Subject: Comments regarding Version 6.0 Draft 2 Computer Specification

The Natural Resources Defense Council (NRDC) and Northwest Energy Efficiency Alliance (NEEA) respectfully submit the following comments in regards to the ENERGY STAR Version 6.0 Draft 2 Computer Specification issued May 15th, 2012.

Figure 2: ENERGY STAR Draft 2 Proposed Desktop Graphics Adders vs. CLASP-NRDC Test Data (Excluding PC4)

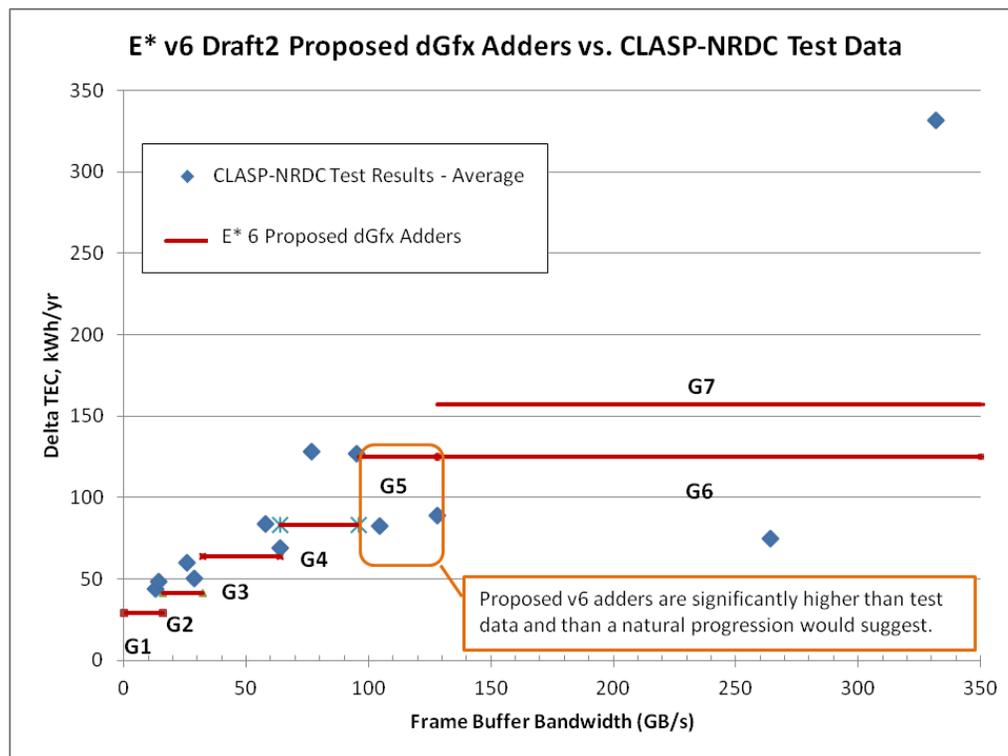
As shown by Figure 1 below, EPA’s proposed dGfx desktop adders are generally consistent with the test results, except in the G5 category where they are significantly higher than what the test data indicates and outside the linear extrapolation of the other ECMA-383 categories.

We are concerned that this creates a loophole which could have serious negative impacts on the effectiveness of the overall specification.

EPA's proposal would give manufacturers 40 kWh/yr more energy than the data suggests is necessary. This is over half of the DT0 TEC allowance (74 KWh) and approximately a third of the DT1 and DT2 TEC allowances. As a result, the proposed G5 adder is in effect giving DT0, DT1, and DT2 desktops between one half and one third extra TEC allowance, allowing potentially inefficient computers using G5 discreet graphics to qualify for the ENERGY STAR label.

We urge EPA to reduce the G5 adder in line with our test data and a natural progression of the G1 – G4 adders.

We also urge EPA to maintain the proposed G4 adder, despite the test data being higher than the proposed G4 adder (See Figure 2). The two G5 cards tested are able to meet the G4 adder, indicating the technology is readily available for G4 cards to meet the specification.

Figure 3: Adders for Second Card vs. Single Card Adders

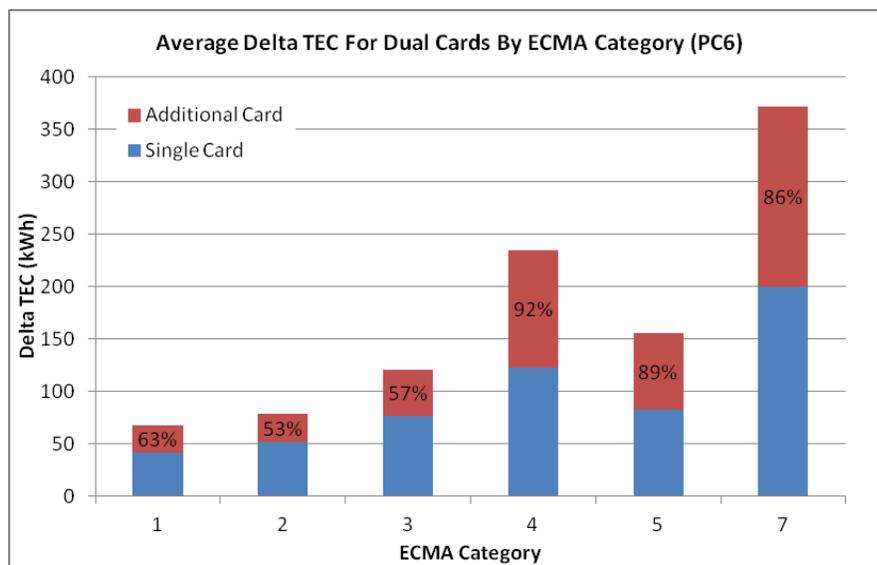
We recommend that adders for additional graphics cards be set at approximately 73% of single card adders.

As presented in the preliminary testing results, the testing shows that adders for second cards are on average 73% of single card adders within each category and therefore that should dictate the second card adder.

Figure 4: Distribution of PSU Load Points at Idle for Desktops⁴

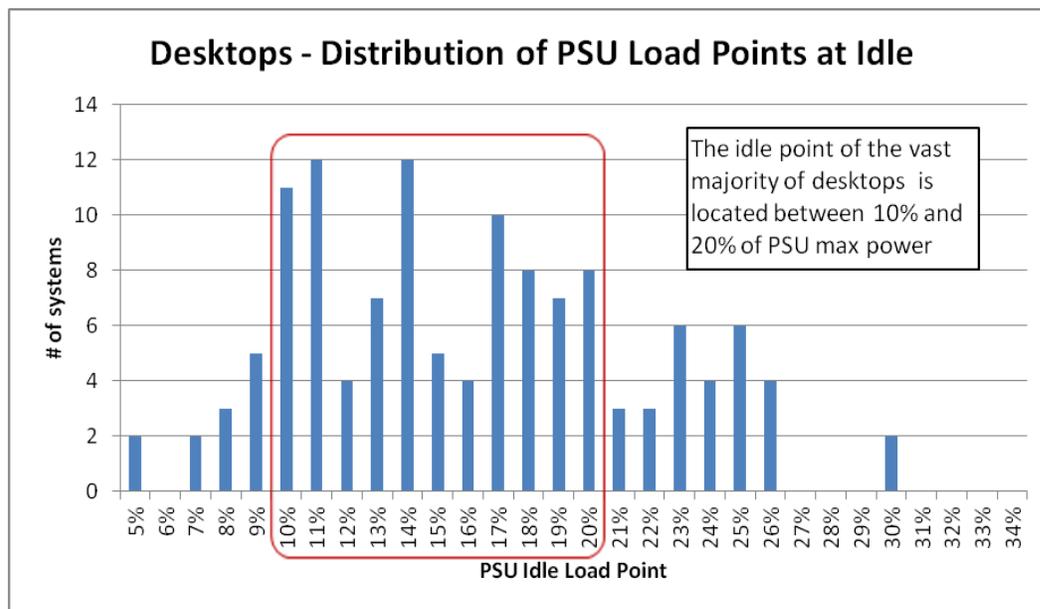
The ENERGY STAR Version 6.0 dataset shows that the majority of computers now have idle PSU load points between 10% and 20%, with an average of 16% for standard desktops and notebooks (see Figure 4 and Figure 5). Therefore, we propose adding a 10%-load efficiency requirement to the standard 80-PLUS and EPS marking protocols.

Figure 6: Efficiency Curves of a Random Sample of 10 80-PLUS Bronze Power Supplies

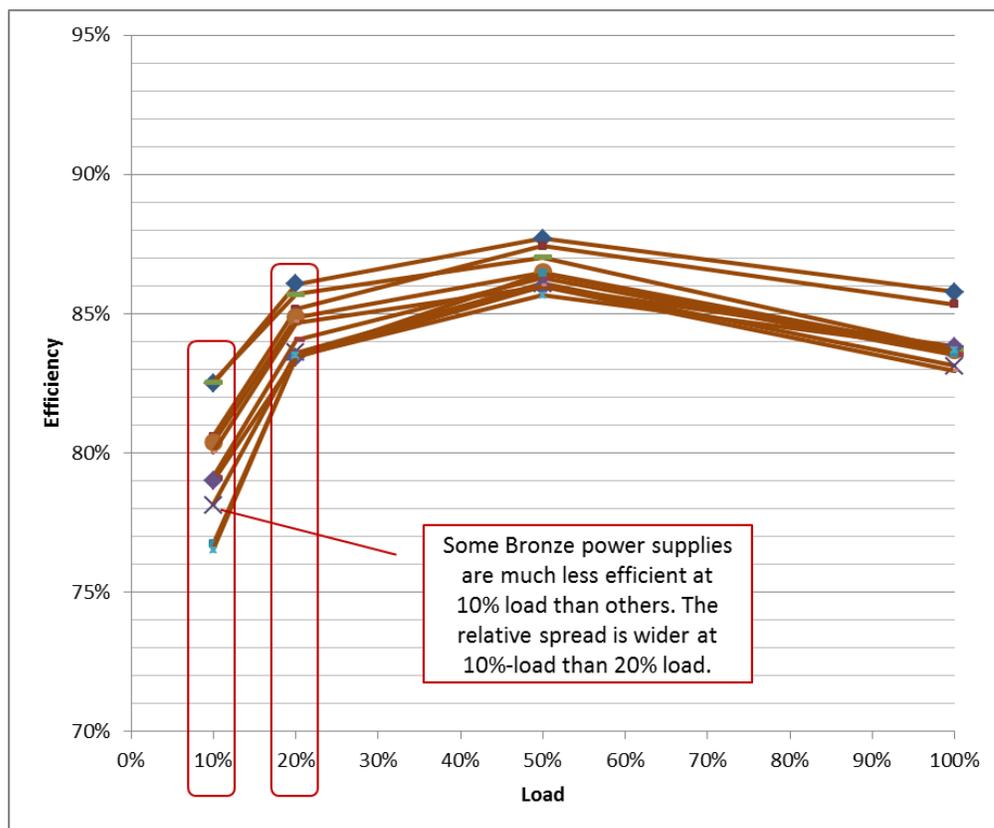
80-PLUS information and test results for internal power supplies show that PSU efficiencies at 10% load vary significantly. For example, Figure 6 below shows a wider range of efficiency at 10% load than at other load points.

Minimum efficiency requirements at 10% load will ensure that power supplies are designed to perform adequately in the entire 10-20% range, which corresponds to the PSU load point of most modern computers. This will become especially important as computers become more power scalable. For example, computers with discrete graphics will continue to require high-power power supplies to run discrete graphics cards in active mode, but will only require a diminishing fraction of that power as they incorporate very-low idle mode graphics technology.

Figure 7: Efficiency Curves of High Efficiency and Standard Efficiency External Power Supplies

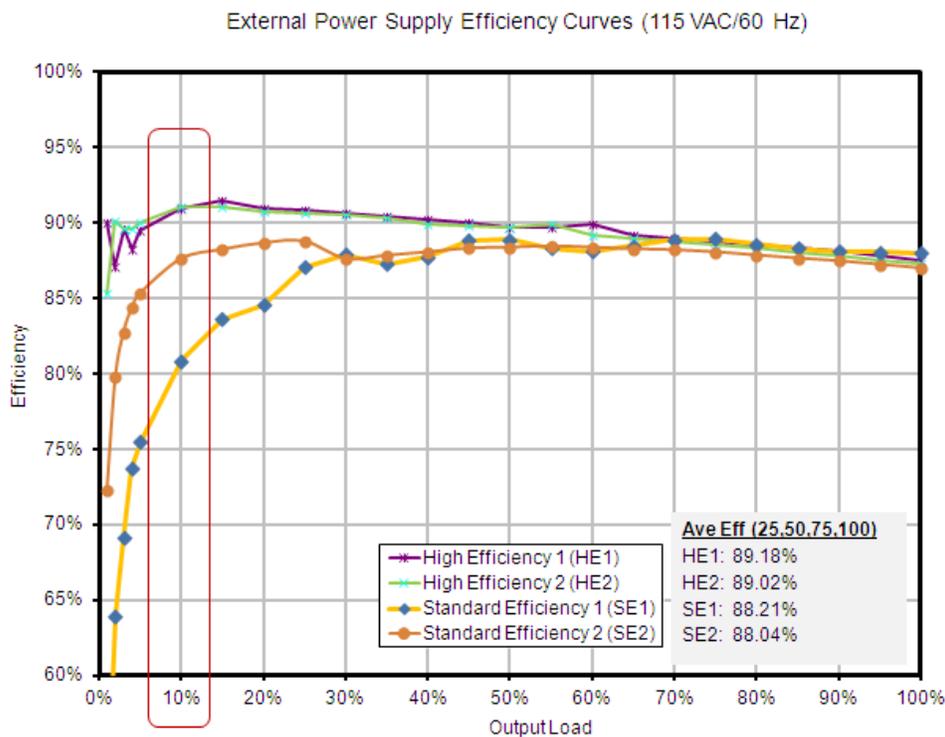
Figure 7 shows 4 EPSs that have similar efficiencies using the average of 25%, 50%, 75%, 100% load metric, but quite different 10%-load efficiencies: 2 models using high efficiency controllers and topologies have 10%-load efficiencies higher than 90%, the other 2 have 10%-load efficiencies of 81% and 87%.
